Access Compliance Report

Public Rights-of-Way

Intersection ID: 4199	Main Street: OLD_STATESVILLE_RD	Cross Street: W_W_T_HARRIS_BV	Location: SW
ADA ID: 42952C23CB22	Ramp Type: Perp	Initial Pass/Fail: Fail	Overall Compliance: No Severity Score: 21.25

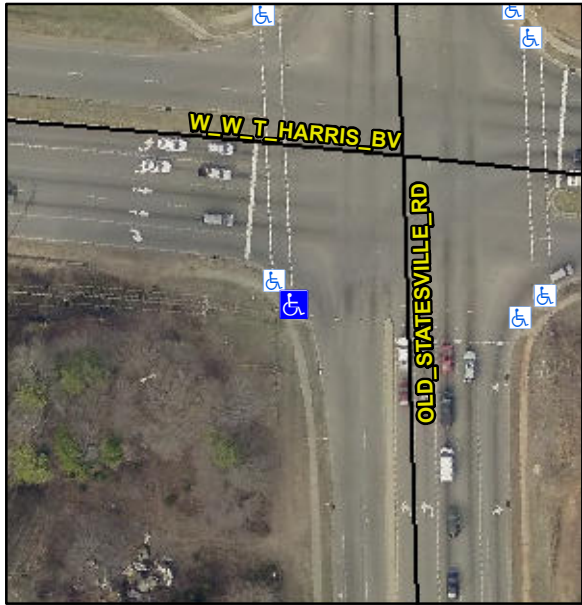
Codes/Mitigation Info/Possible Solution			Field Measurements/Component Compliance					
	Possible Solutions:		Compliance	Description	Data	Compliance	Description	Data
	Remove & Replace Entire Ramp.		N/A	Ramp Length (in)	63.5	No	Ramp Slope (%)	9.8
			No	Ramp Width (in)	40.5	Yes	Ramp XSlope (%)	0.4
			N/A	Flare Type LT	N/A	N/A	Flare Type RT	N/A
			N/A	Flare Slope LT (%)	N/A	N/A	Flare Slope RT (%)	N/A
			N/A	Flare Traversable LT?	N/A	N/A	Flare Traversable RT?	N/A
			N/A	Landing Length (in)	N/A	N/A	DWS Provided?	N/A
			N/A	Landing Width (in)	N/A	N/A	DWS Contrast?	N/A
			N/A	Landing Slope (%)	N/A	N/A	DWS Length (in)	N/A
			N/A	Landing X Slope (%)	N/A	N/A	DWS Full Width?	N/A
Surveyor Notes: N/A			N/A	Landing Curb? (Y/N)	N/A	N/A	DWS Offset (in)	N/A
			N/A	Shared Landing?	N/A			
			N/A	Gutter Ponding?	N/A	N/A	Gutter Slope (%)	N/A
			N/A	Gutter Lip Ht (in)	N/A	N/A	Gutter X Slope (%)	N/A
			N/A	Painted X Walk1?	Yes	N/A	Painted X Walk2?	N/A

X Walk 1 Direction	To SE		X Walk 2 Direction	N/A
			N/A	X Walk 1 Width (in)	98.0	N/A	X Walk 2 Width (in)	N/A
				X Walk 1 Slope (%)	1.0		X Walk 2 Slope (%)	N/A
				X Walk 1 X Slope (%)	0.2		X Walk 2 X Slope (%)	N/A
			N/A	Ramp inside XWalk1?	Yes	N/A	Ramp inside XWalk2?	N/A
PROW/ADA: Not Found, R304.5.1, R304.2.2				Road Slope (%)	N/A	N/A	Clear Space?	N/A
				Road X Slope (%)	N/A	N/A	Clear Space to XWalk (in)	N/A
			N/A	Any Obstructions?	N/A	N/A	Storm Grate/Utility Hazard?	N/A
				Obstruction Type			Storm Grate/Utility Type	
					N/A			N/A
						Yes	Surface Condition? (G/P)	Good
Total Cost: \$ 1850.00
